## Addendum No. 4

Date: 05-20-2024

Project Name: NECSD – New CTE Building

CSArch Project No. 108-2303

CTE  
S004

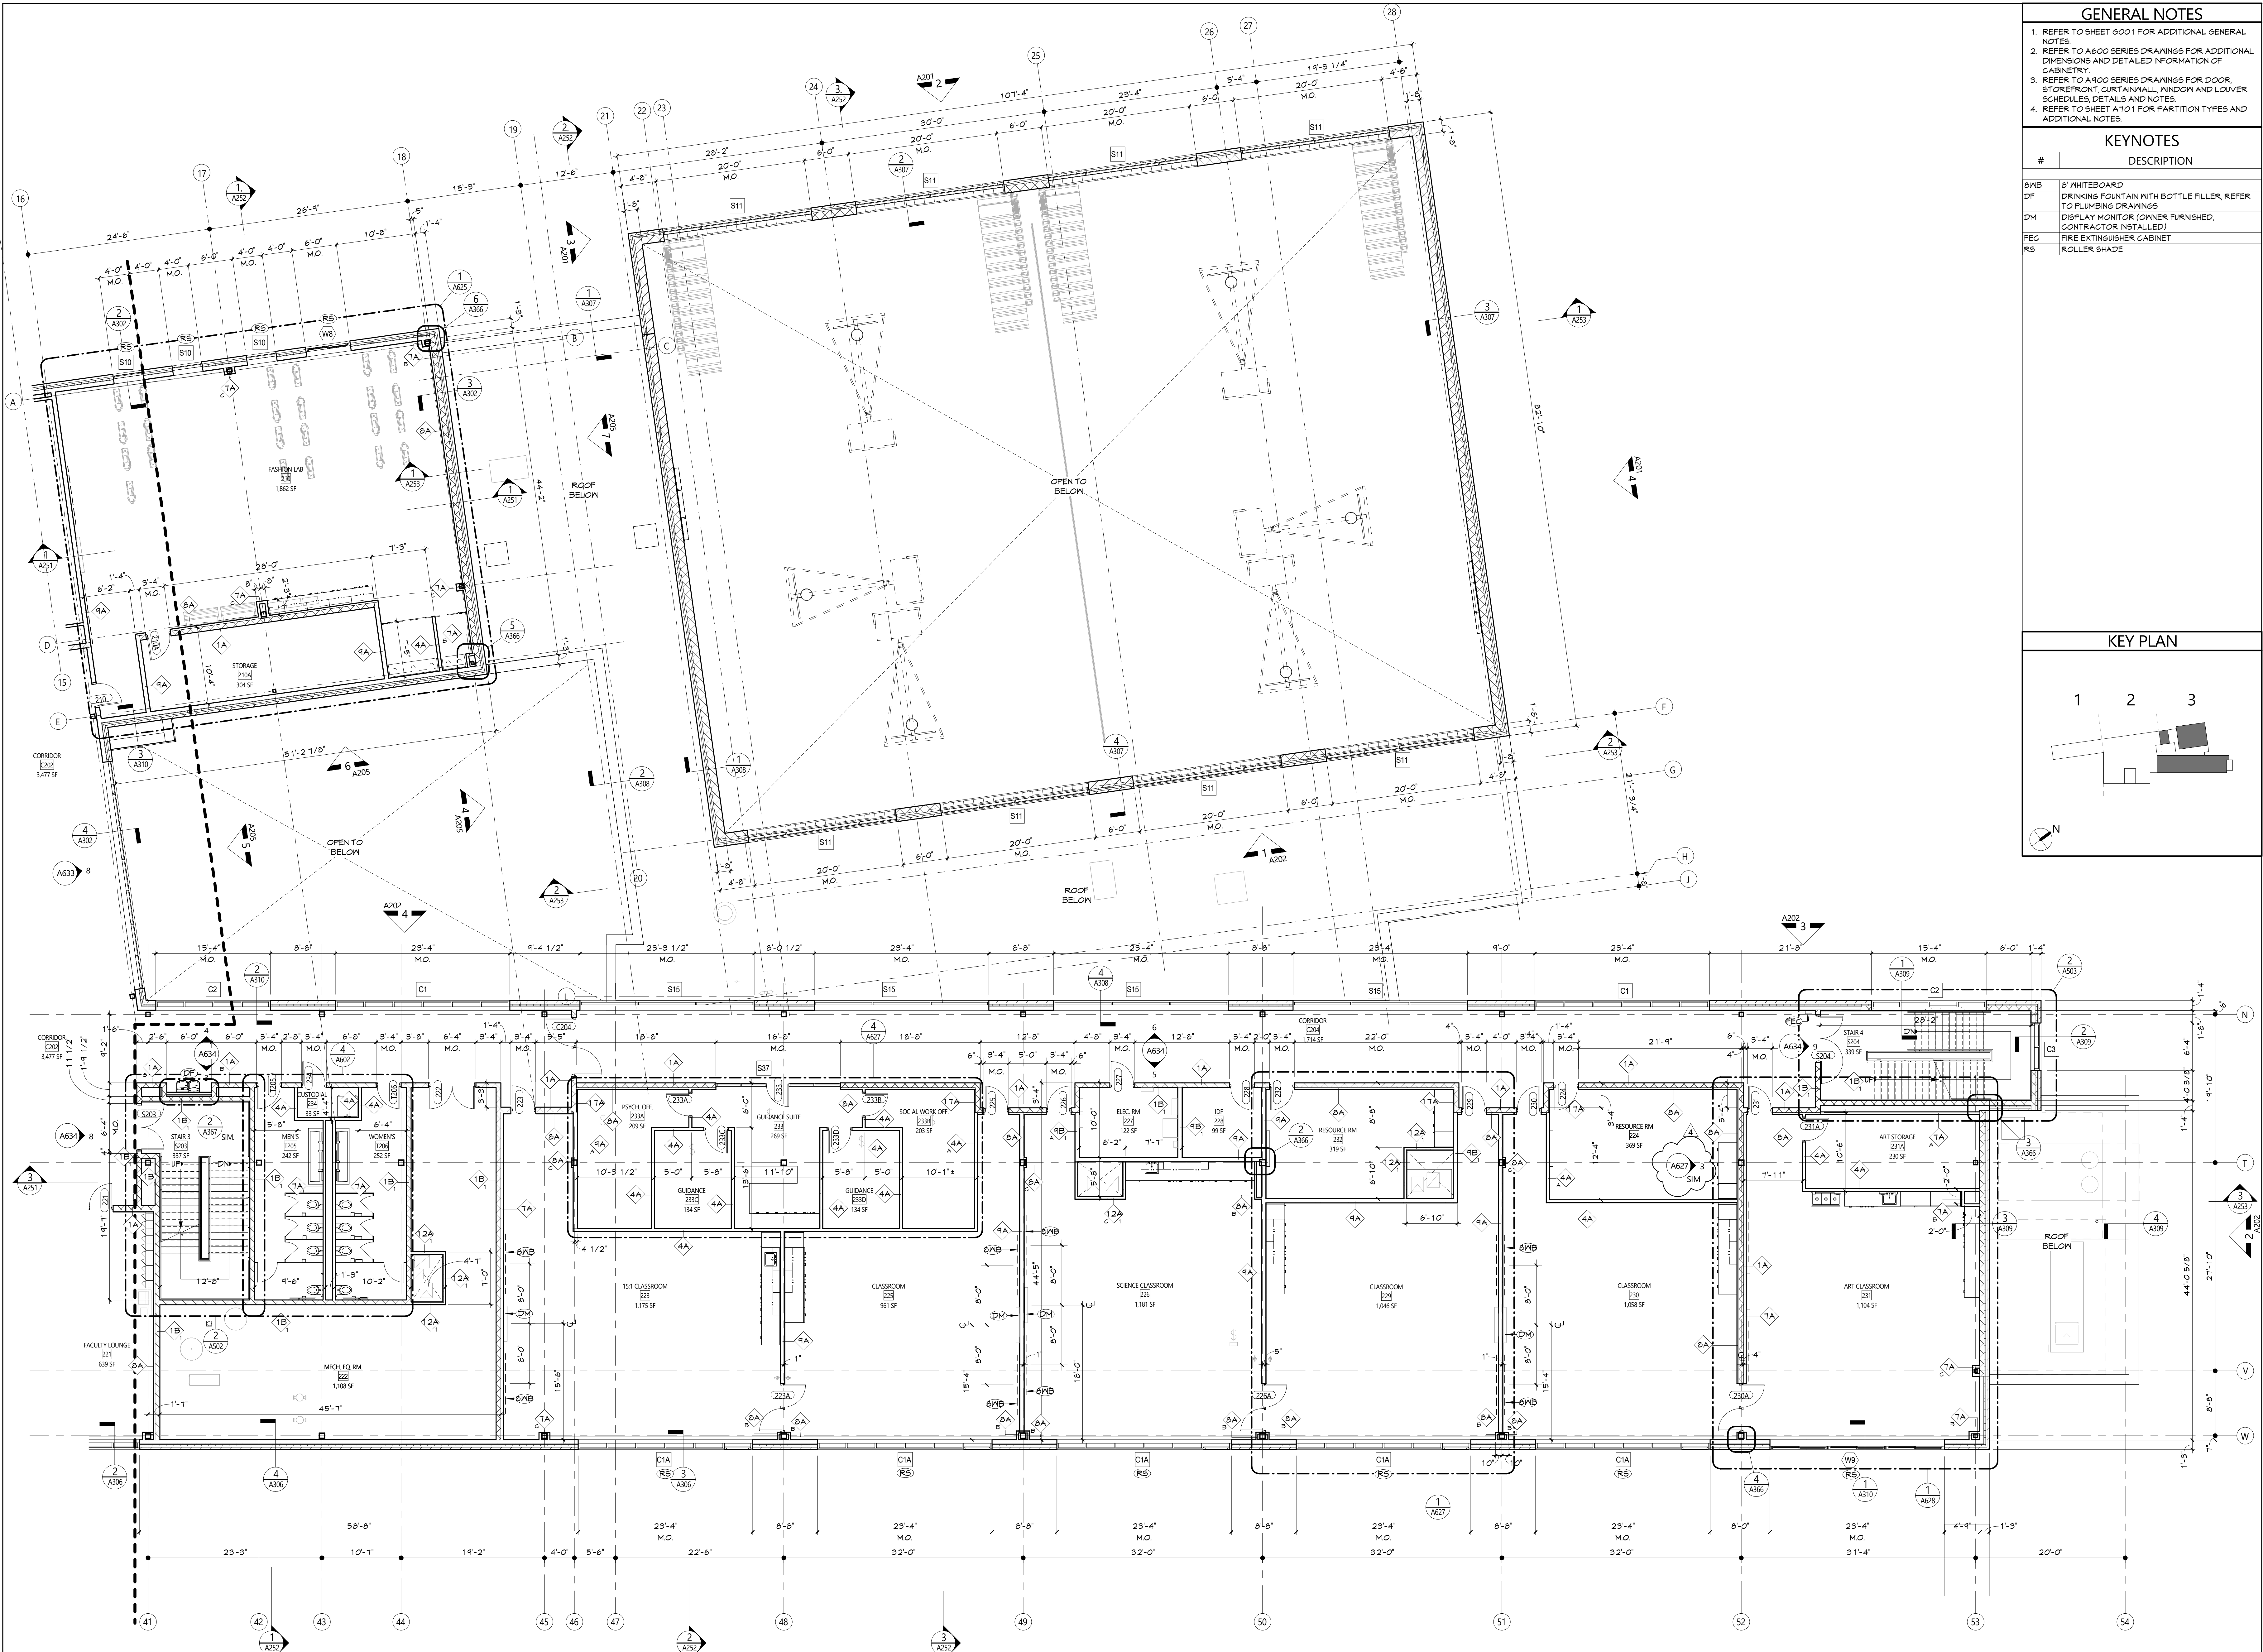
99	A	078100 - Applied Fire Protection	There is a discrepancy between the Life and Safety sheets LS101-LS102 and the specification section 078100. The Life and Safety plans show fireproofing plans that it calls out for the SOFP to be rated for 1-hour, whereas the specification section called for roof construction and supporting beams and joist to be 2-hours. Which of the two different rating should we abide by?	5/13/2024	Dobco, Inc.	Revised as part of addendum #4	Yes		078100	Add #4
100	S	Column Schedule	Column F-20 is scheduled to receive intumescent paint. The column schedules do not call out what the F-20 column is. Please determine the size of the HSS member at location F-20.	5/13/2024	Dobco, Inc.	Provided as part of addendum #4	Yes	S004		Add #4
101	S	Column Schedule	The column schedule legend shown on sheet S004 called out FP “Denotes fireproofing treatment required on column (do not shop prime).” This is correct when applying fireproofing but some of these columns will receive intumescent paint. Steel to receive intumescent paint is required to be shop primed with a compatible primer.	5/13/2024	Dobco, Inc.	Revised as part of addendum #4	Yes	S004		Add #4

**3** PARTIAL BUILDING SECTION  
A253 1/8" = 1'-0"

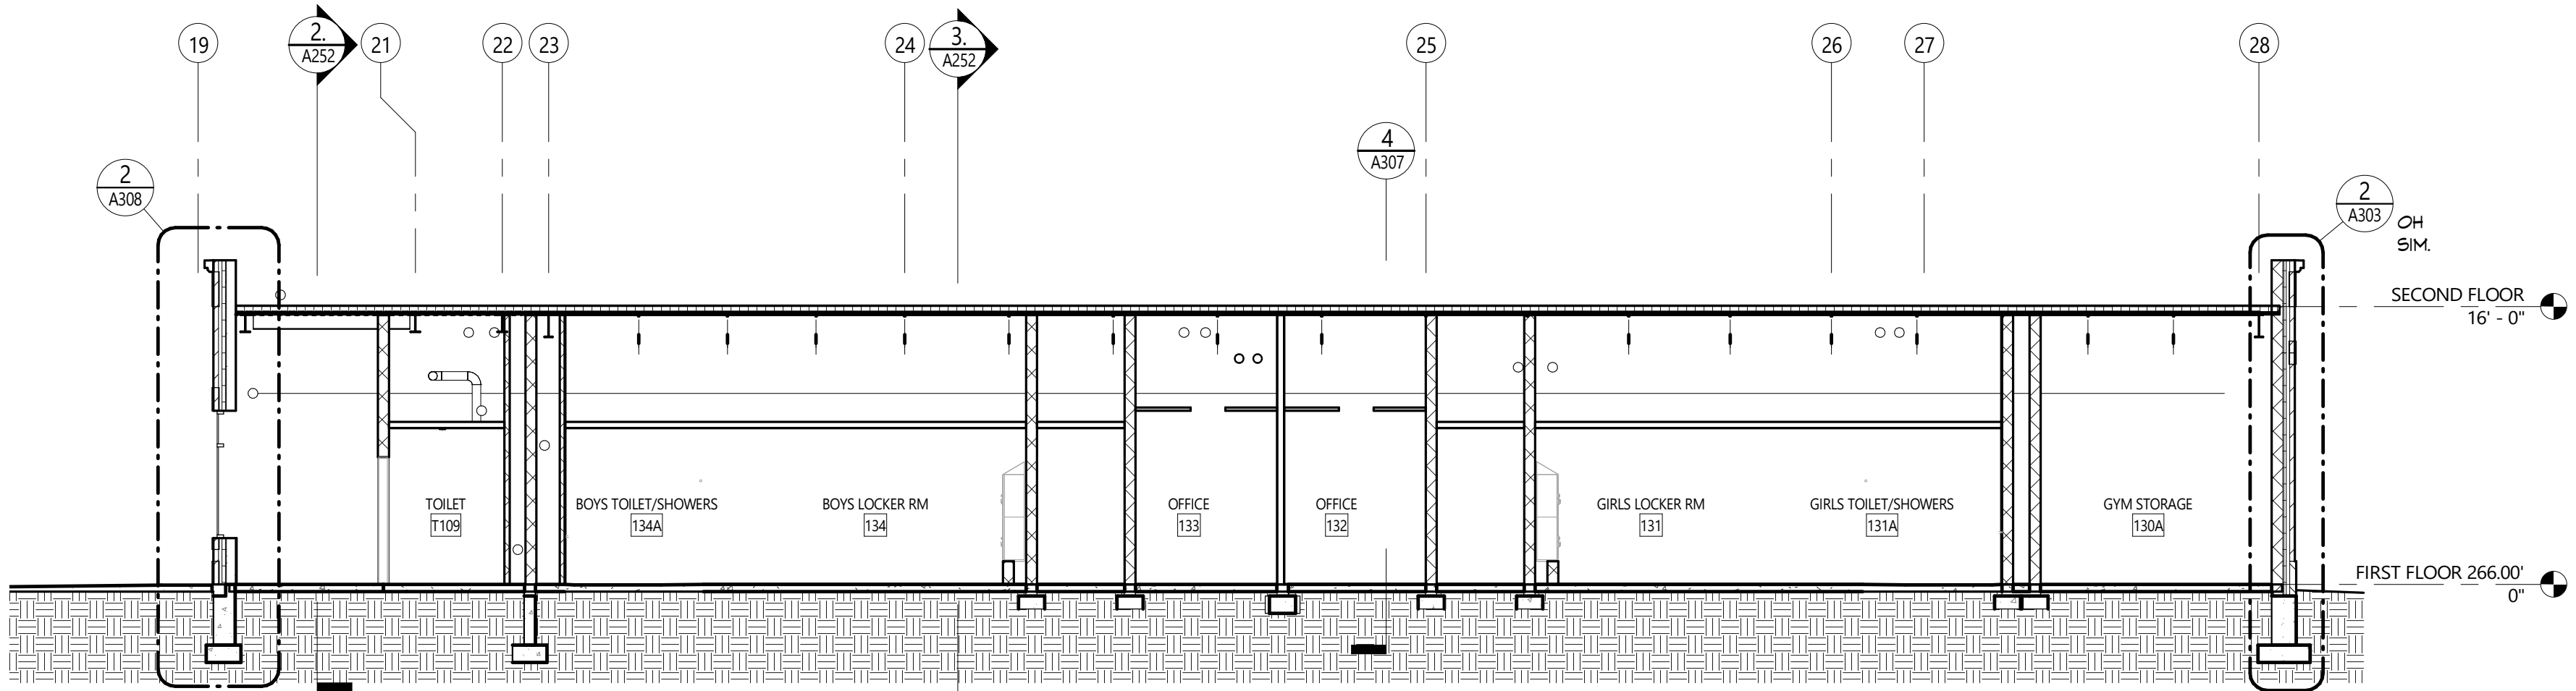
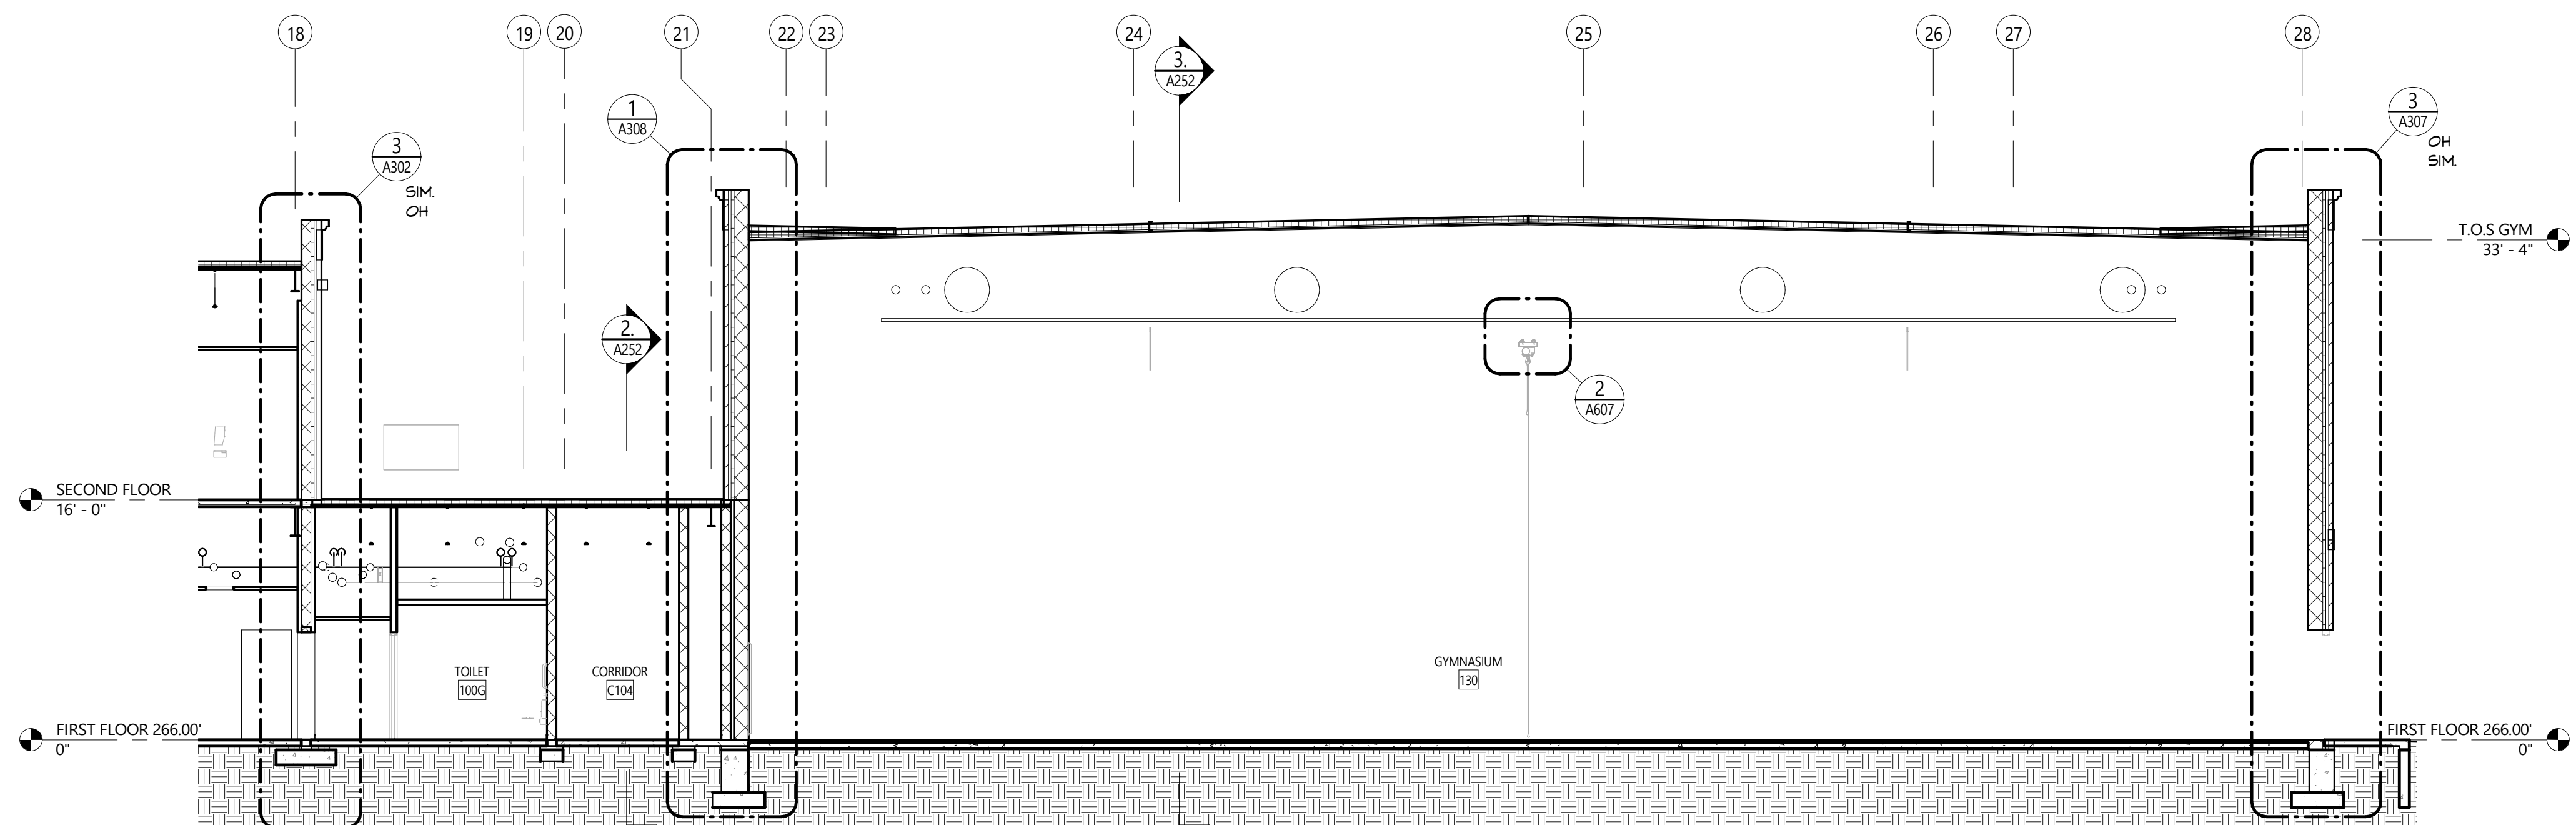
102	A	Intumescent Paint	Clarify what primer will be applied for the steel to receive intumescent paint.	5/13/2024	Dobco, Inc.	Bid as per specification section 078123, 2.3, B.	No			
103	A	Wall Construction	Detail 3 on sheet A309 wall construction notes do not match the section drawn. Wall construction called out 2” of spray foam insulation of 5/8” exterior sheathing, and the detail shows rigid insulation being applied to CMU block. Which of the two different wall constructions should be abide?	5/13/2024	Dobco, Inc.	Revised as part of addendum #4	Yes	A309		Add 4
104	A	Wall Construction	Detail 3 on sheet A253 shows two details (3/A351 and 9/A354) representing the base and top of an exterior wall. These two details show two different wall constructions. 3/A351 has spray foam on exterior sheathing and 9/A354 has rigid insulation on cmu block. Please clarify the wall construction type in this area.	5/13/2024	Dobco, Inc.	Revised as part of addendum #4	Yes	A253		Add 4

1 WALL SECTION  
A303 1/2" = 1'-0"

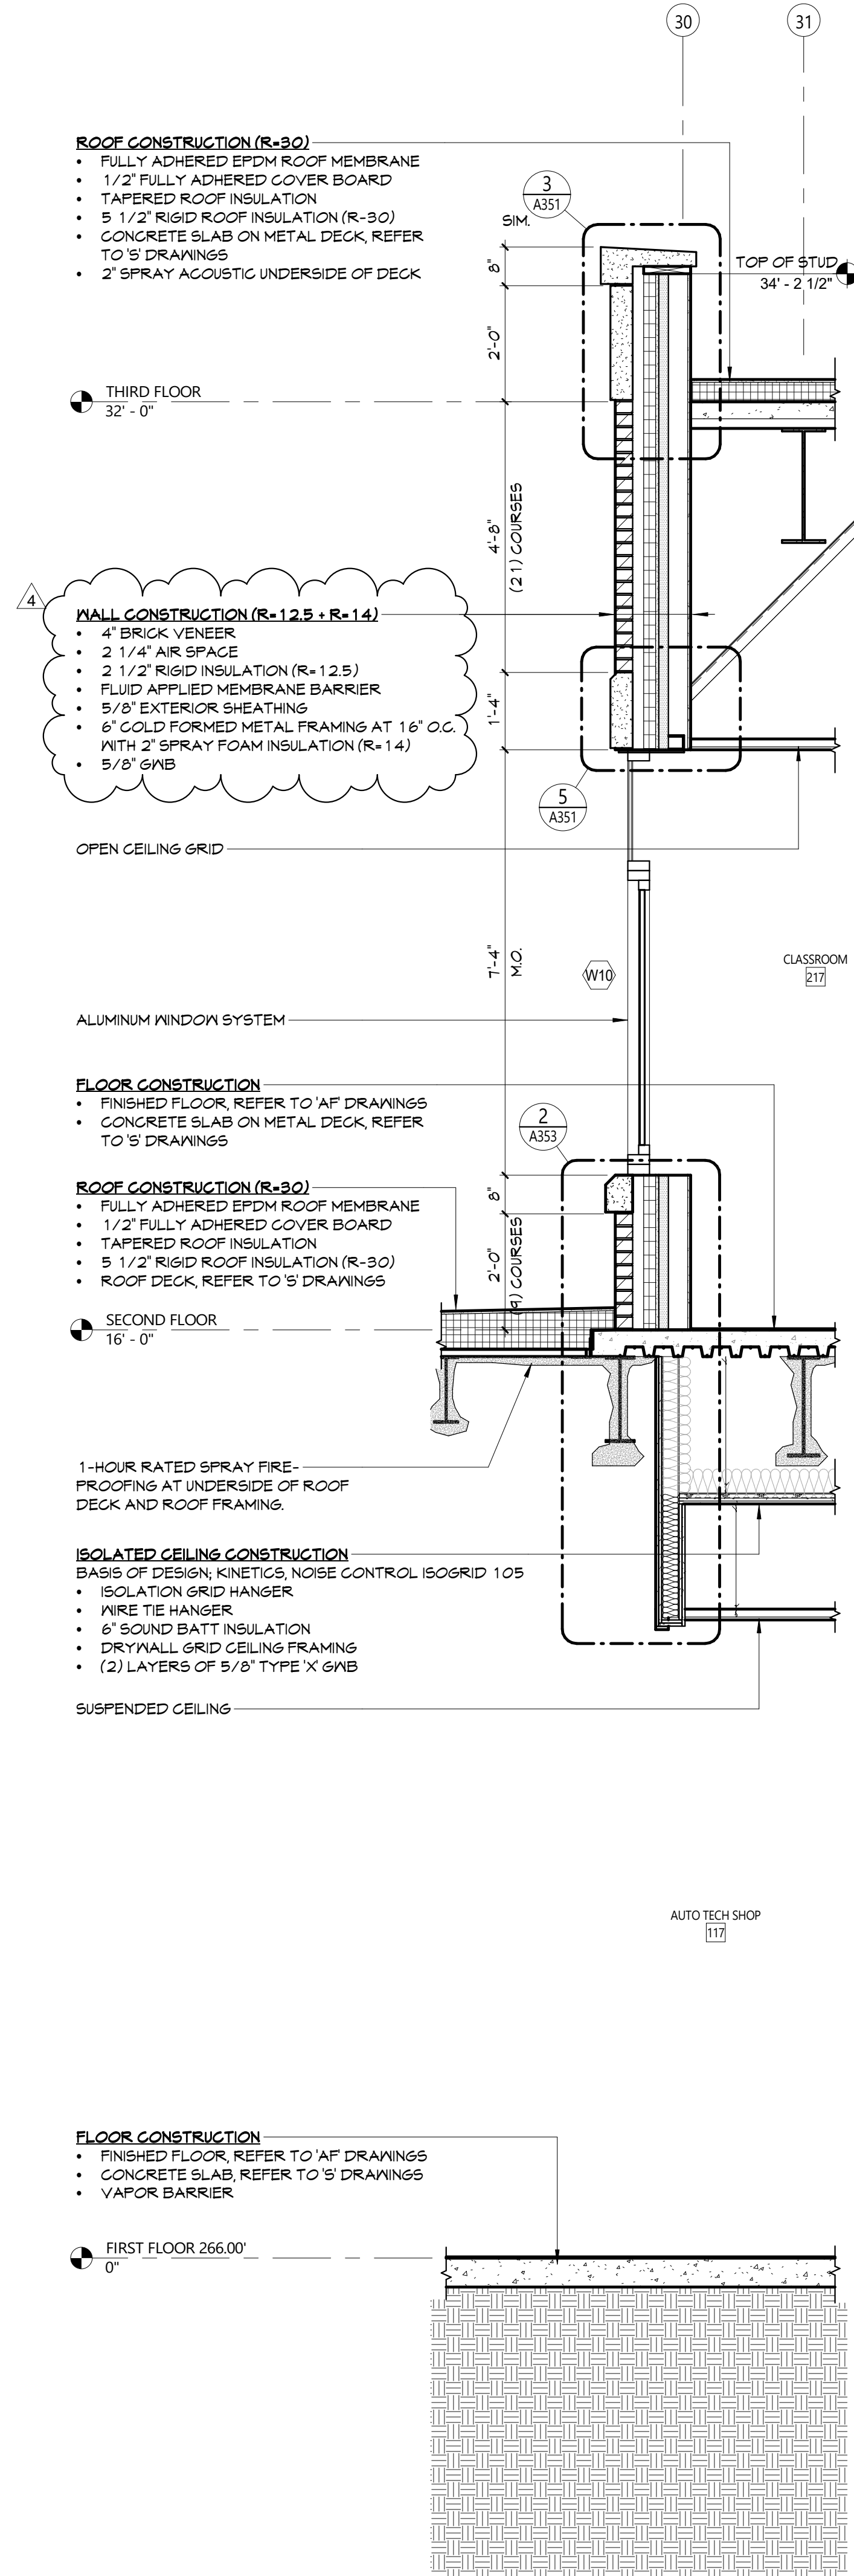
105	A	Wall Construction	Detail 1 of sheet A303 wall construction calls for 8” CMU with fluid applied membrane barrier and 2-1/2” rigid insulation; the wall itself does not match the description it is given. Please clarify if this wall is supposed to be CMU or 6” CFMF with 2” of spray foam insulation as drawn.	5/13/2024	Dobco, Inc.	Revised as part of addendum #4	Yes	A303		Add 4
